**220 Arkell Road – Guelph, ON
Environmental Impact Study Addendum**

Final Report

April 17, 2023

C-400

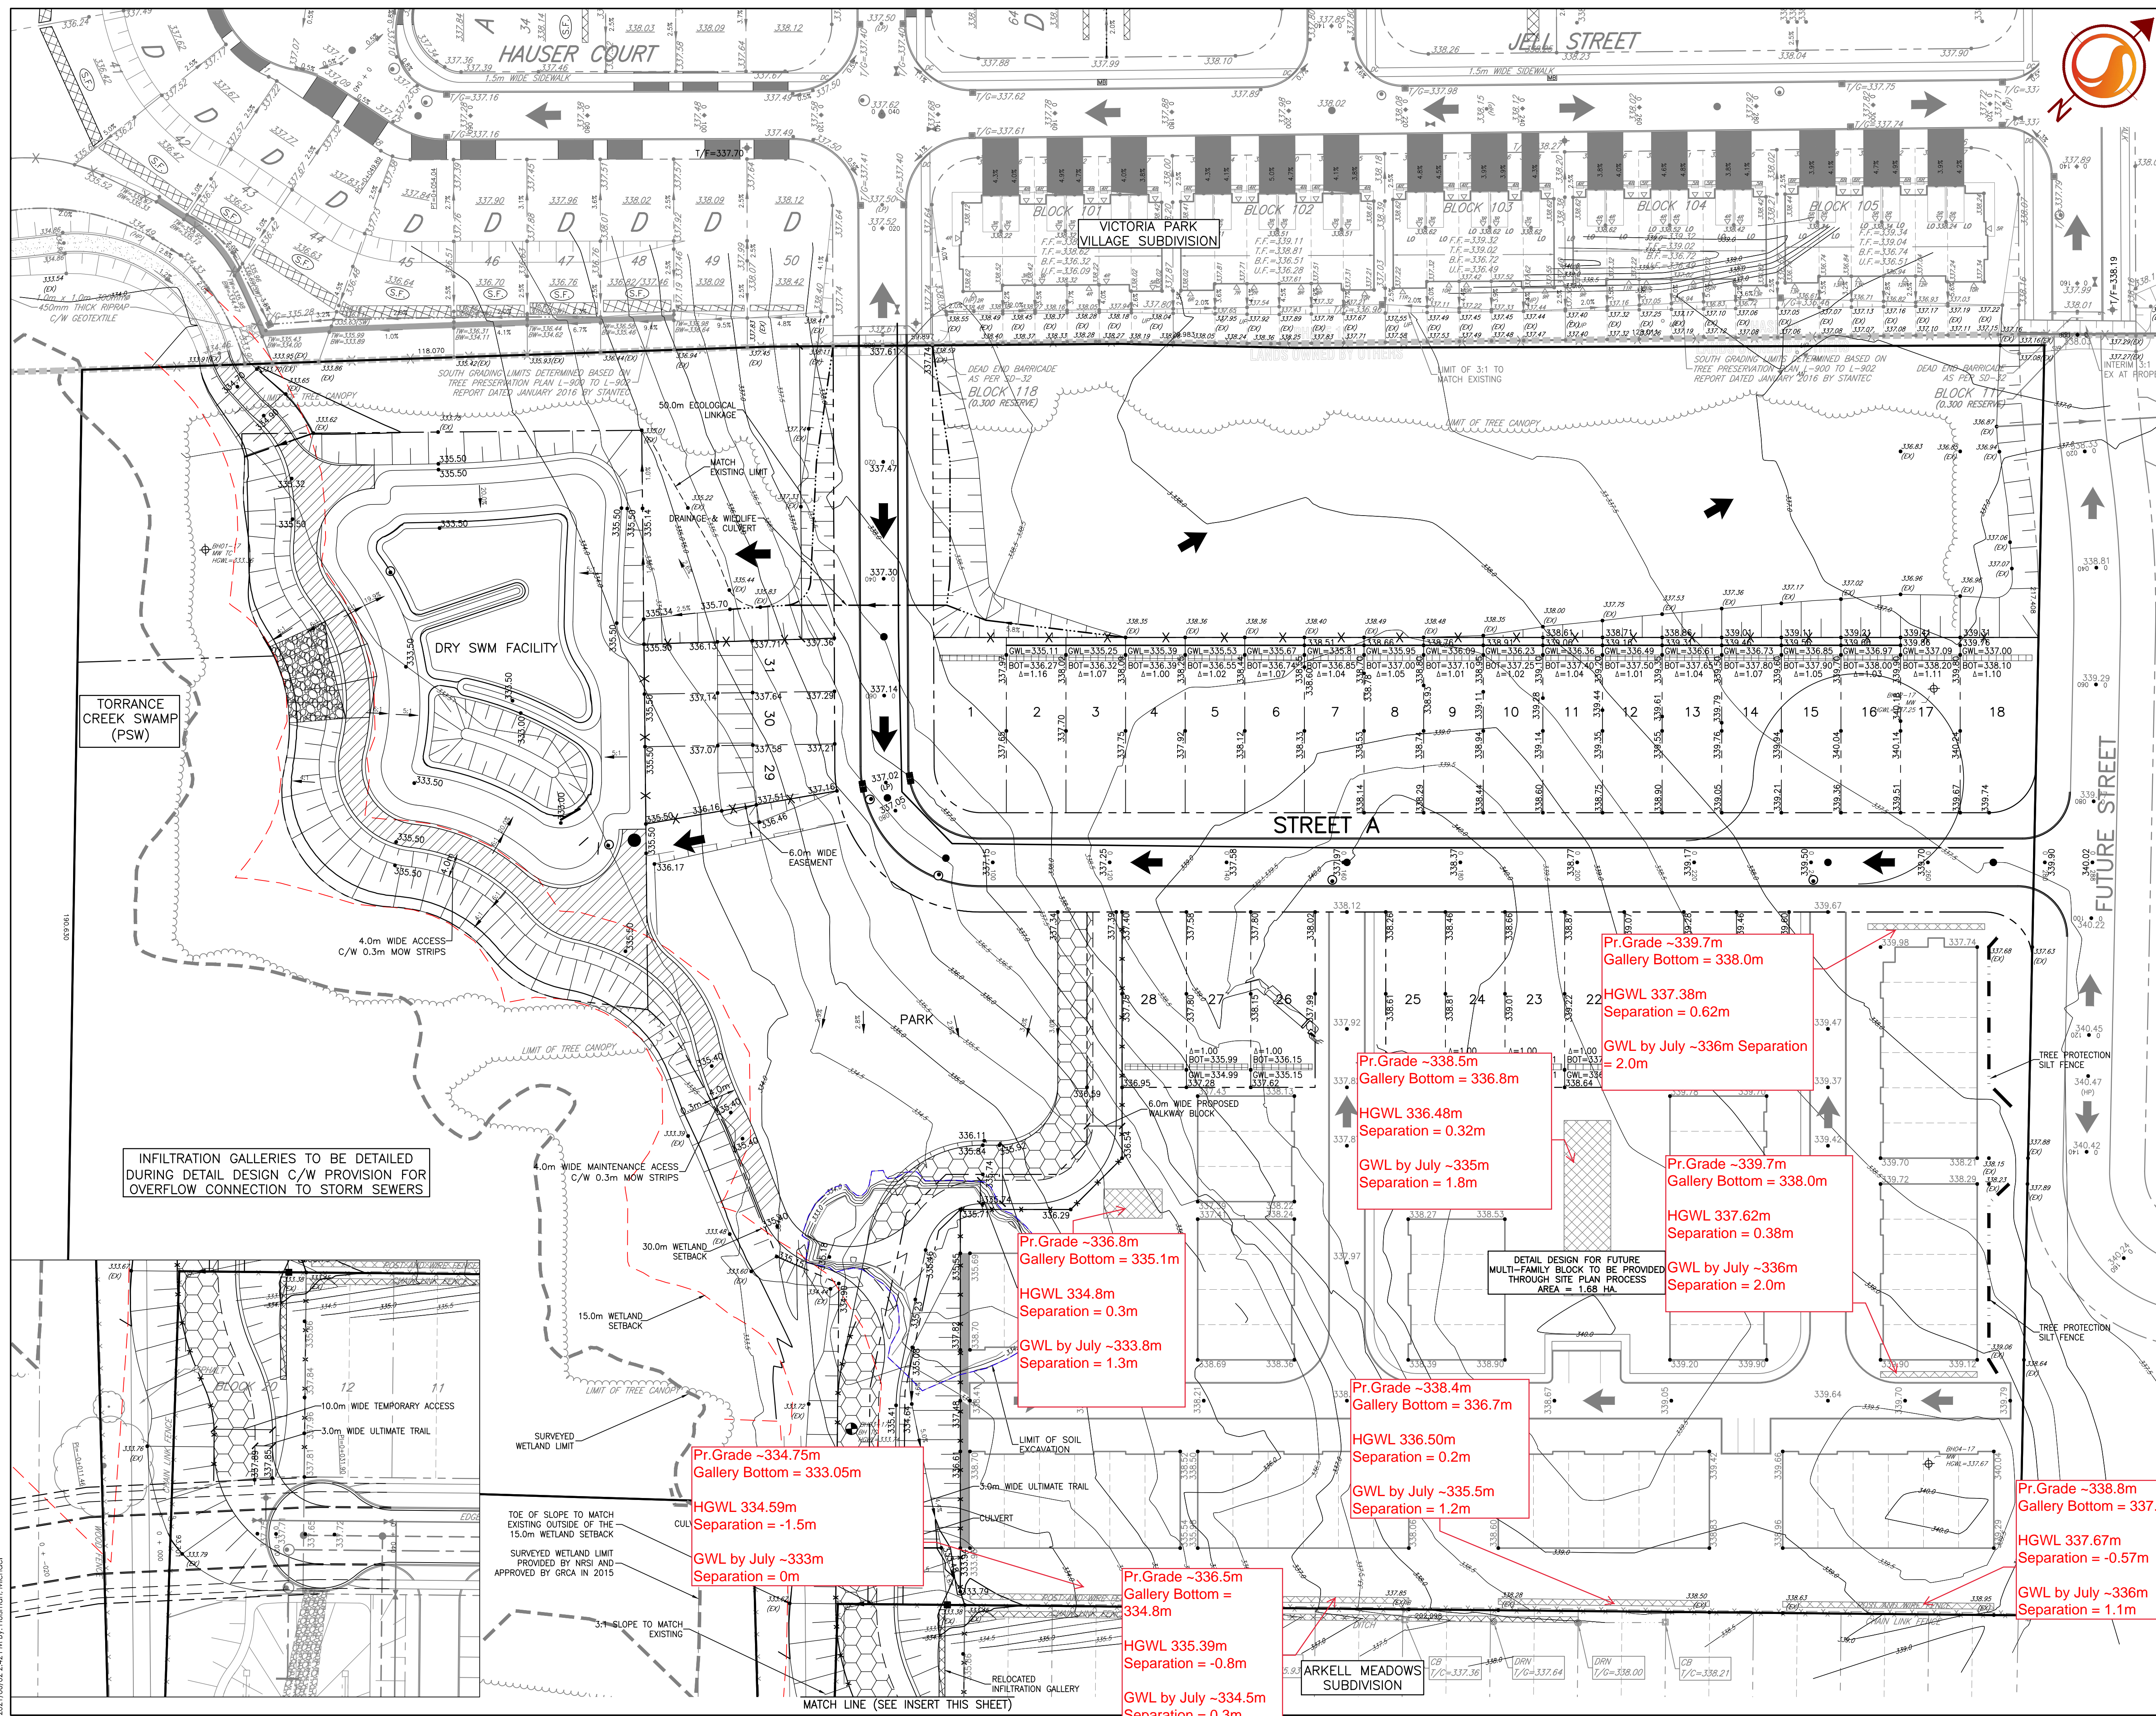
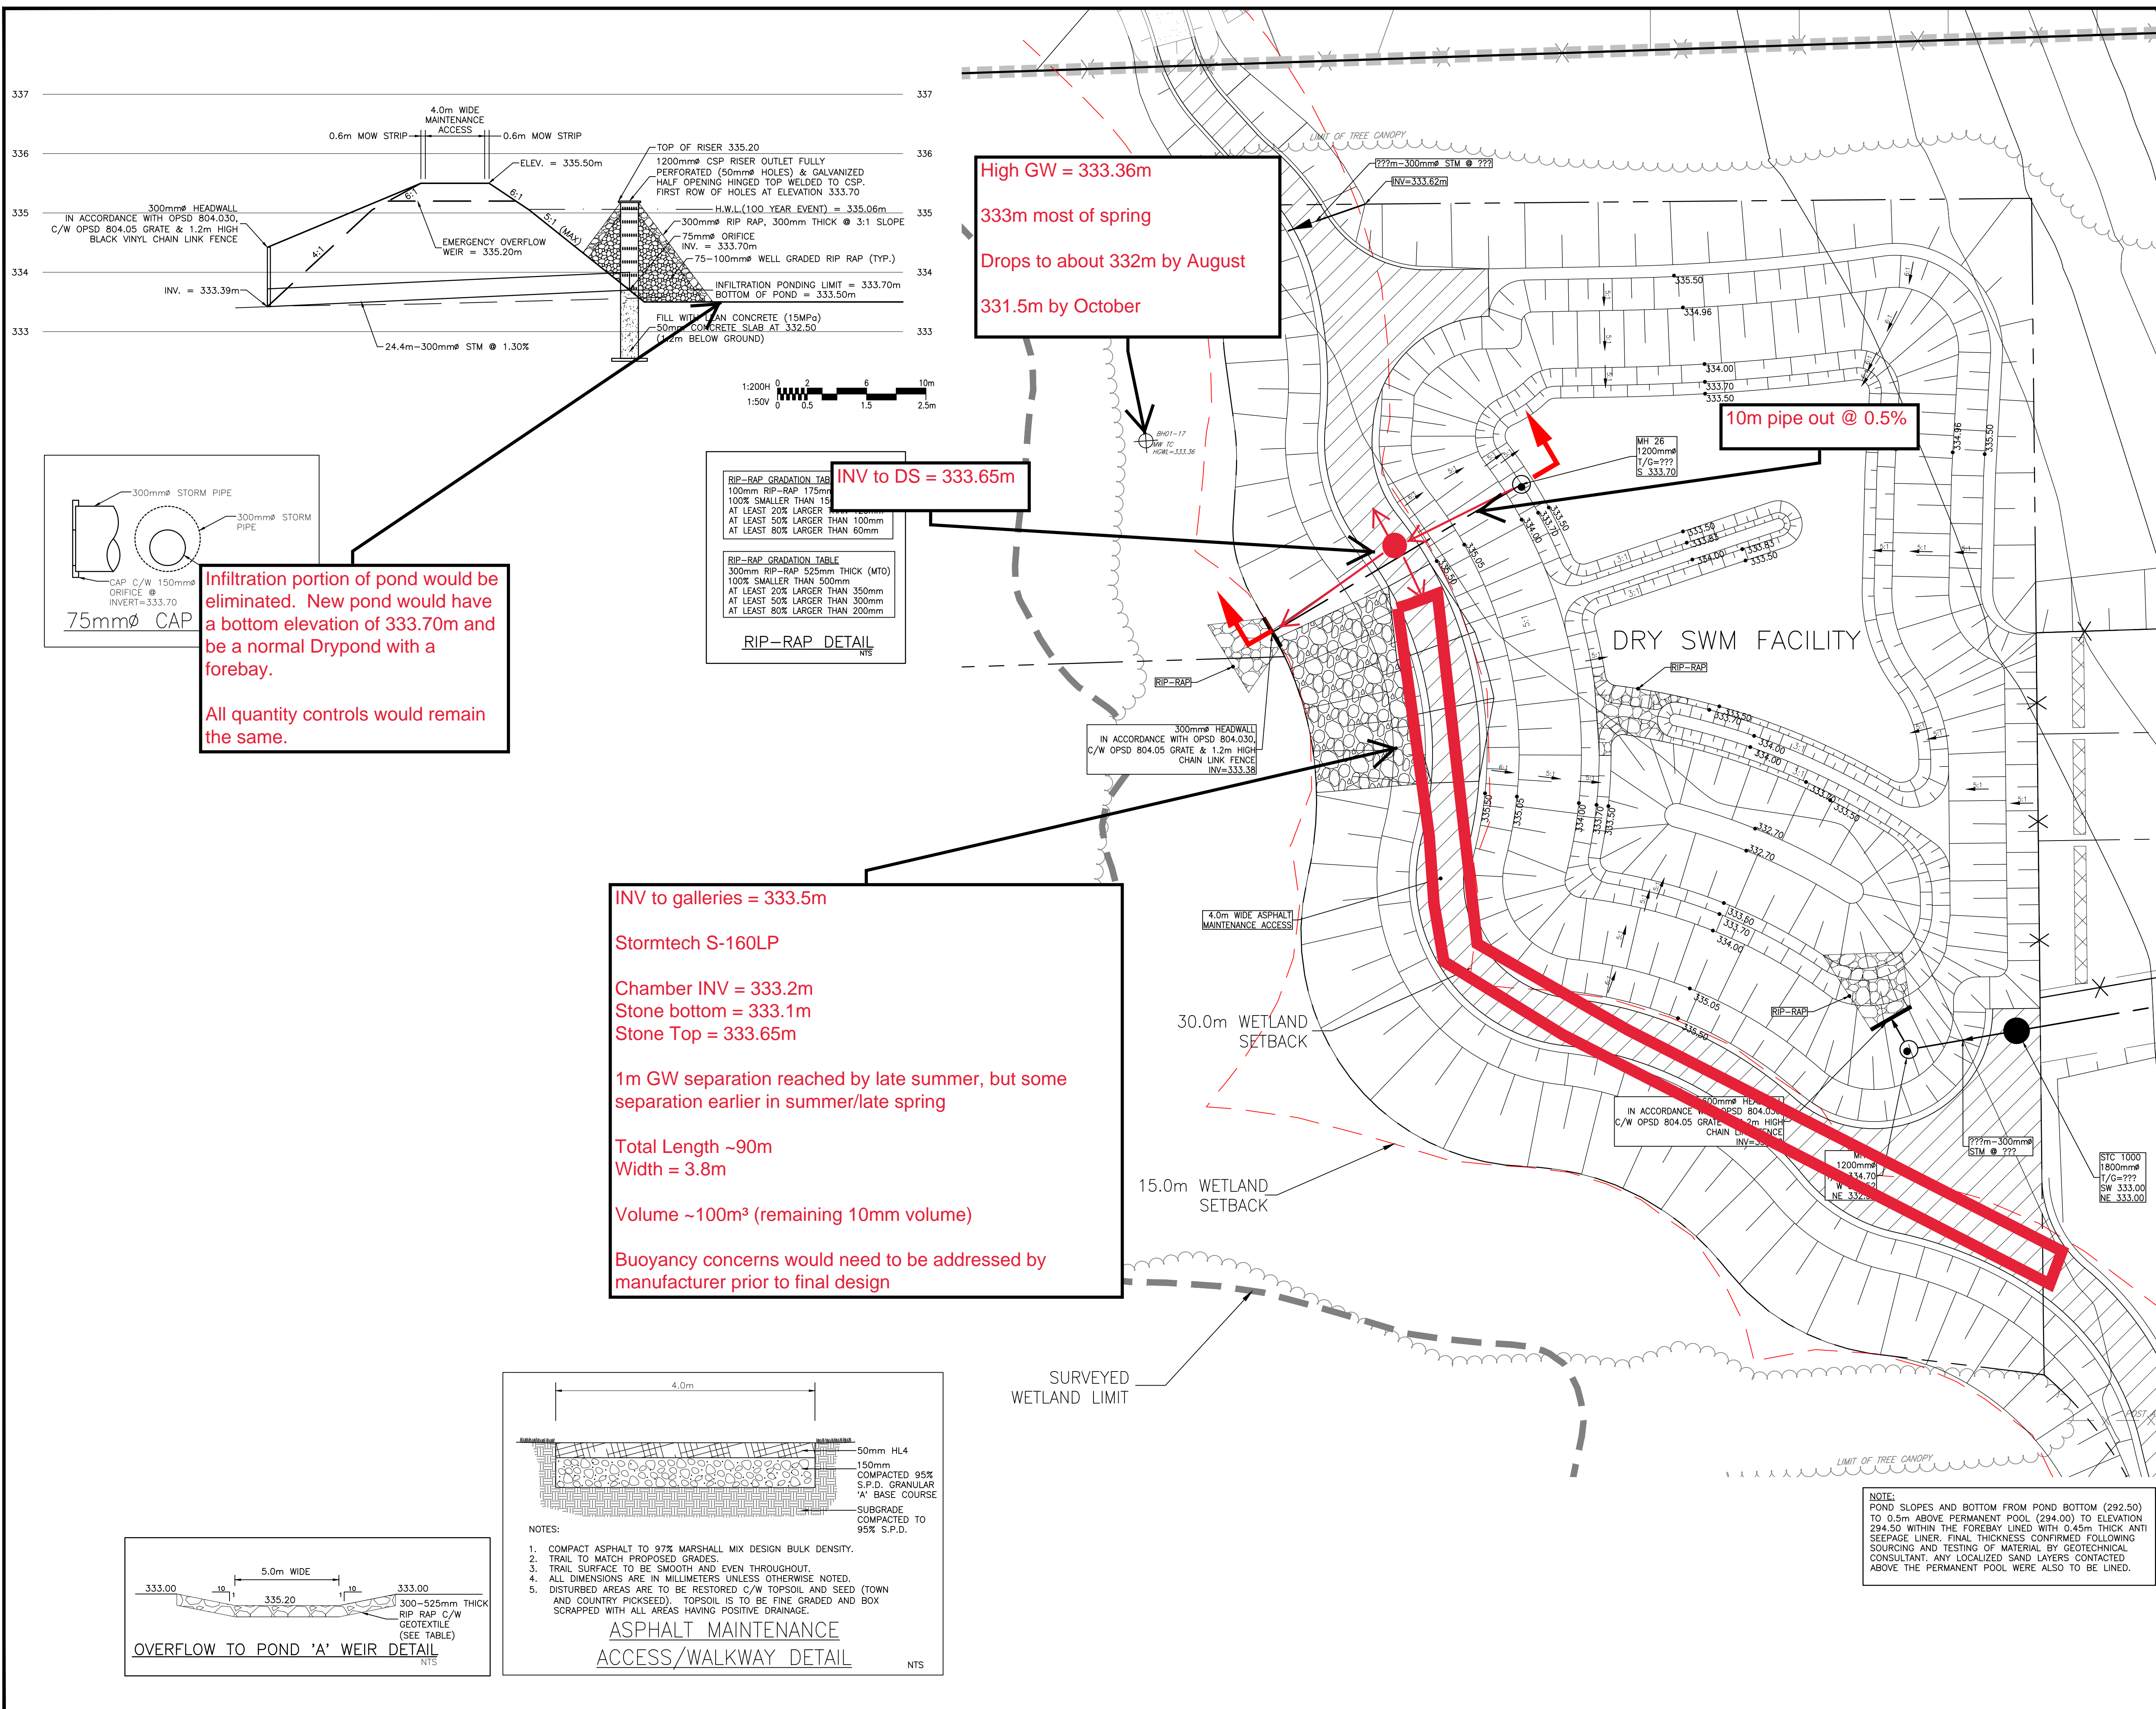
Drawing C-400 Conceptual Grading Plan		
38.0	C	Is a culvert needed under the pathway at the northwest side of the SWMF? Drainage arrows and information in the report indicate the area north of the pond drains to the west, but the conceptual grading information indicates it will not get there, but will spill into the lots to the north.
	R	Culvert and drainage slopes added to clarify drainage pattern
